SUBJECT: Forwards response to 820422 request for addl info re util
 response to IE Bulletin 80-11, "Masonry Wall Design."

Re: Nine Mile Point Unit 1
Docket No. 50-220
DPR-63

Additional Information
Regarding Inspection and Enforcement
Bulletin 80-11

Masonry Walls

MASONRY WALL DESIGN - Wall #31

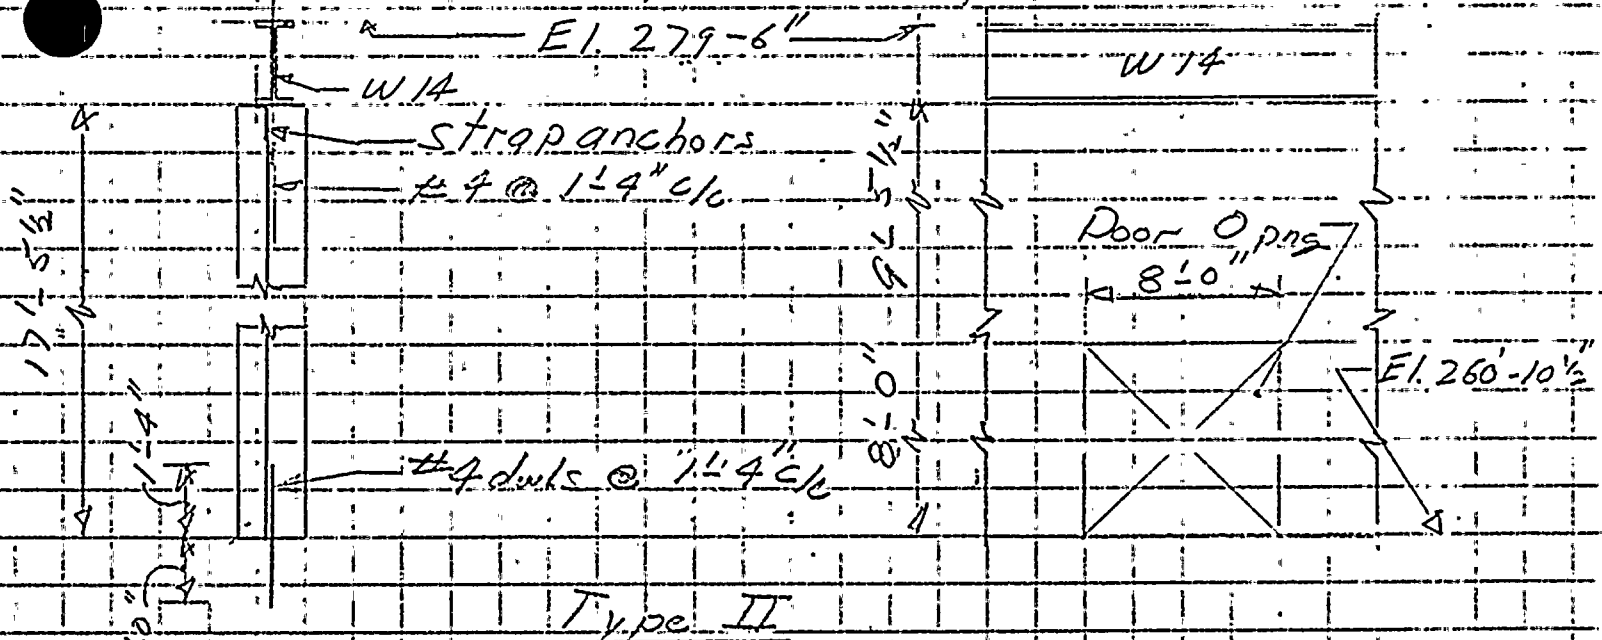
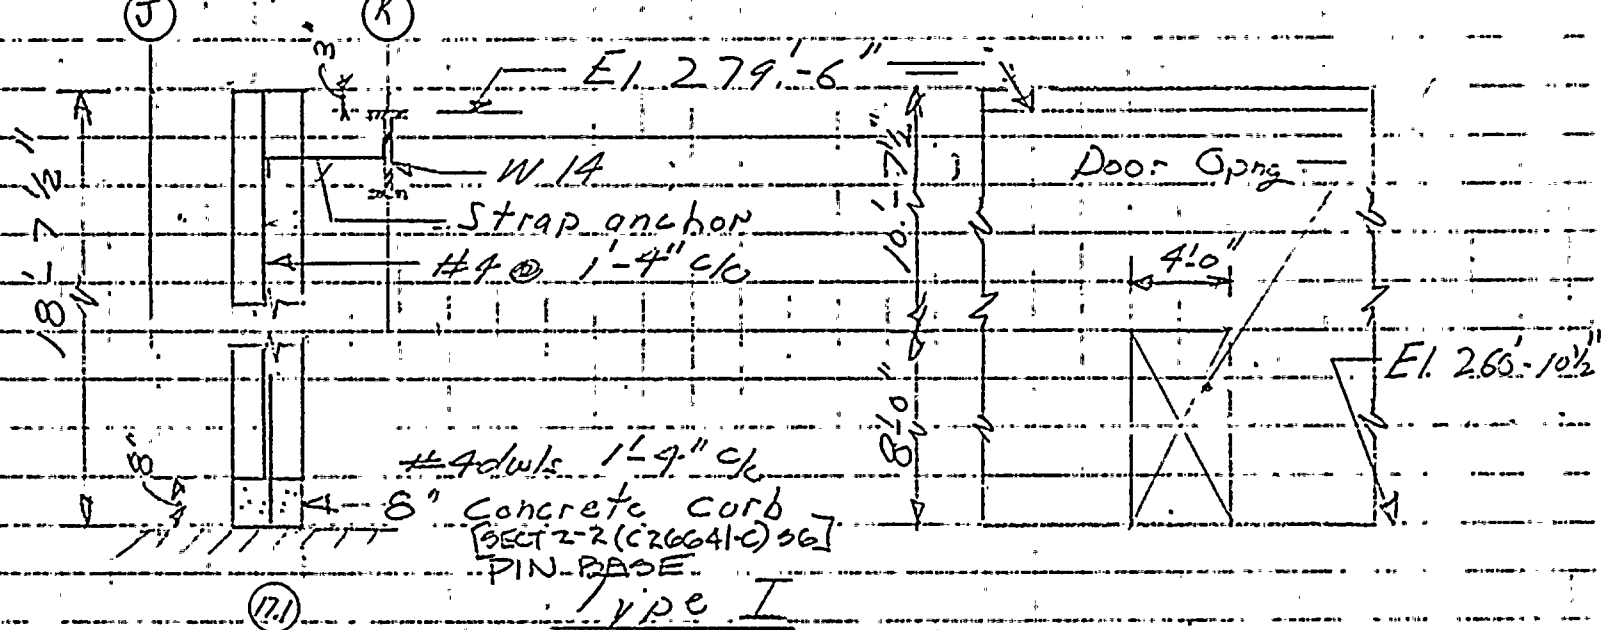
Provide sketches of the proposed wall modifications [3] and indicate, using sample calculations, how these modifications will correct the wall deficiencies. Indicate the out-of-plane drift effects of the bracing added to walls 31, 44, 45, 59 and 66 as stated in Reference 3.

Type I 11 5/8" hollow block wall will assume to act as cantilever due to buckling of strap anchor. See page 16 for anchor strap calculations ✓

29,687 Psi > 20,000 Psi NG 40 Grade Steel ✓

Must use pin connection at top. Strap anchors must be stiffened up to take compression load. Use simple beam moment (See pg 16).

See attached calculations and sketches. Out-of-plane drift effects will not cause overstress due to the limiting nature of the support deflection.

SUBJECT NINE MILE POINT UNIT #1
Masonry Wall Bulletin #80-11
Wall # 31 Fix

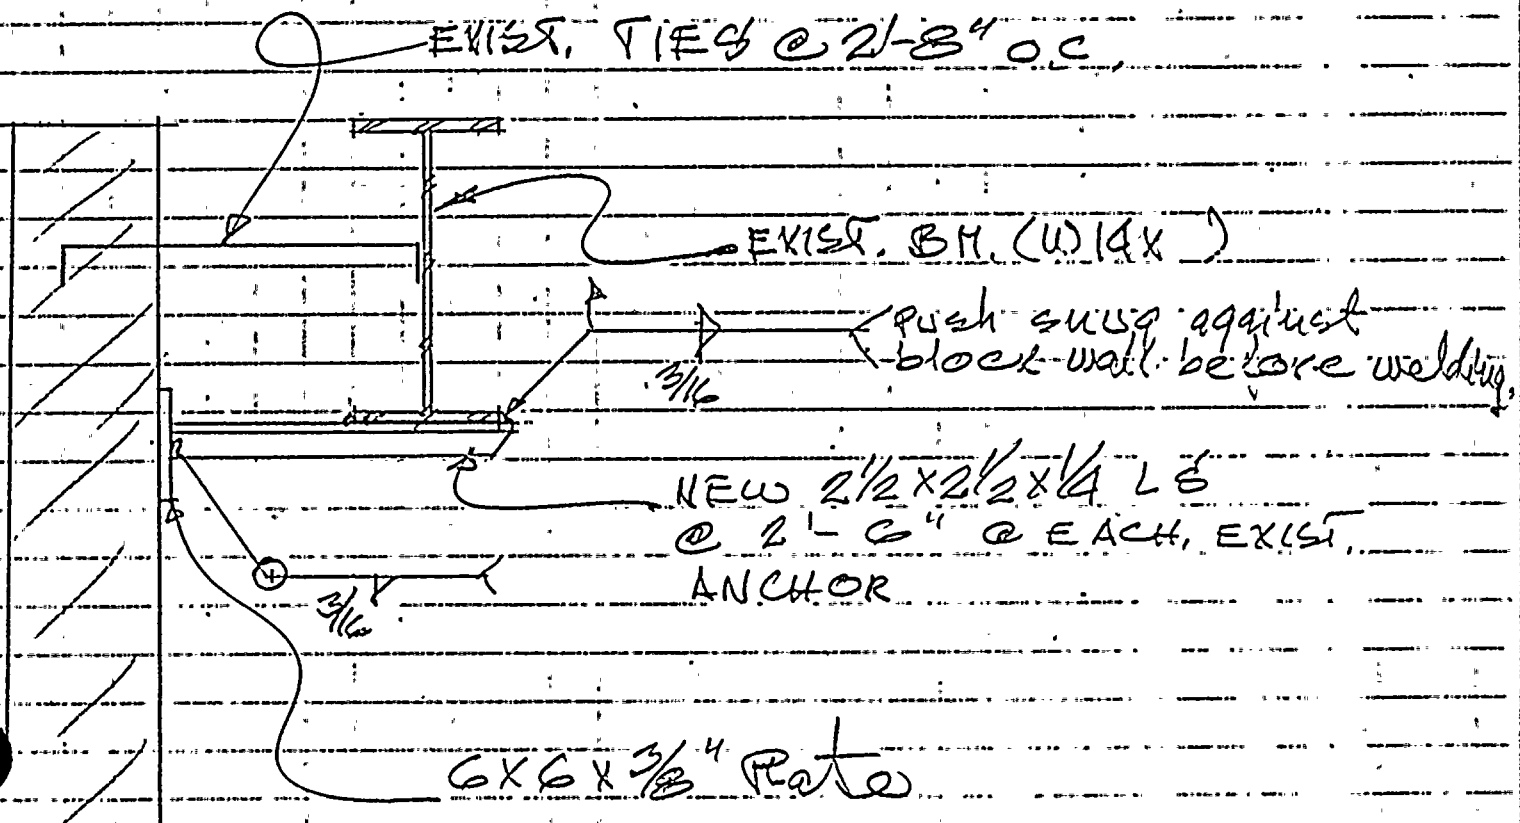
Anchor Straps will have to be stiffened. The wall is adequate in flexure from previous calcs (pages 6 - 13).

Force per anchor less than 200 #
(see orig. calc's.)

$$200 / (2 \times 2 \frac{1}{2} \times \frac{3}{16} \times .707) = 302 \text{ psi negligible weld}$$

EXIST. anch. OK! in tension
(see orig. calc's.)

WALL # 38✓

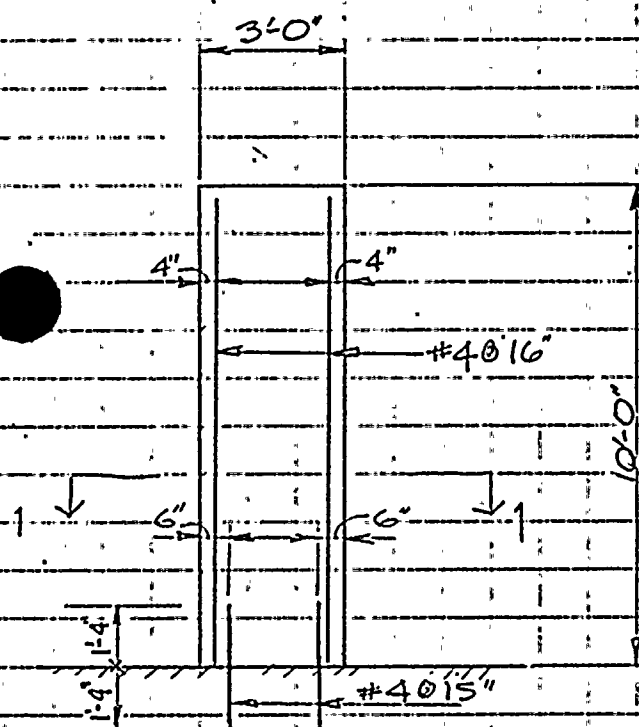
Provide a brief description and sample calculations to show the analytical approach used for single wythe and multiple wythe walls.

The masonry walls at Nine Mile Point Unit 1 were re-analyzed using ACI 531-79. Calculations for single and multiple wythe walls are attached.
